## EARLY DESIGN GUIDANCE OF THE NORTHEAST DESIGN REVIEW BOARD

Project Number: 3012744

Address: 4558 7th Ave NE

Date of Meeting: Monday, November 07, 2011

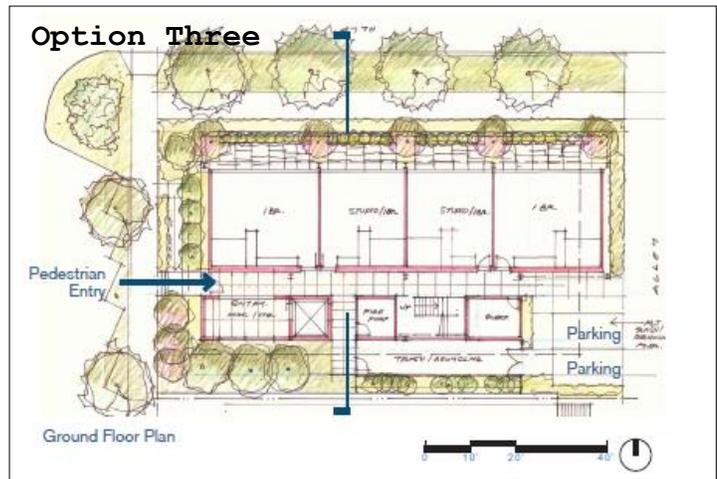
At the Early Design Guidance Meeting, the Board supported the preferred option with the narrowest building profile and setting back further from the street, creating less intrusive massing. This slender profile is the least intrusive and minimizes the bulk to neighbors.
